Final Environmental Impact Report

Motte Business Center Project

SCH No. 2022120083

November 2023

Page 2-10, Exhibit 2-3: Existing General Plan Land Use Designations

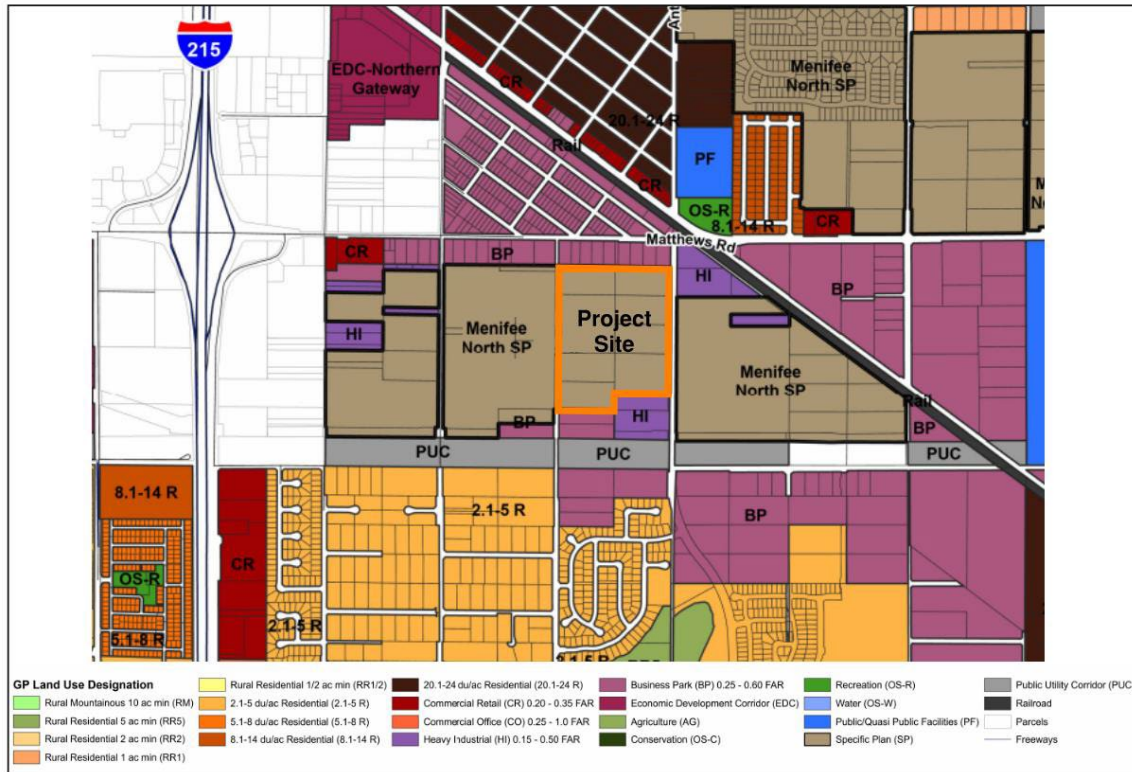
The site's existing land use designation is "Menifee North Specific Plan (SP)" (see **Exhibit 2-3: Existing General Plan Land Use Designations**). The Project's proposed industrial uses are consistent with the existing land use designation. The City's General Plan (GP) Land Use Map was amended March 23, 2023 ~~December 15, 2021~~.¹ The Project site's existing zoning is Menifee North SP Industrial (see **Exhibit 2-4: Existing Zoning**). The Project's proposed industrial uses are consistent with the existing zoning. The City's Zoning Map was amended ~~February 18, 2022~~ March 23, 2023.²
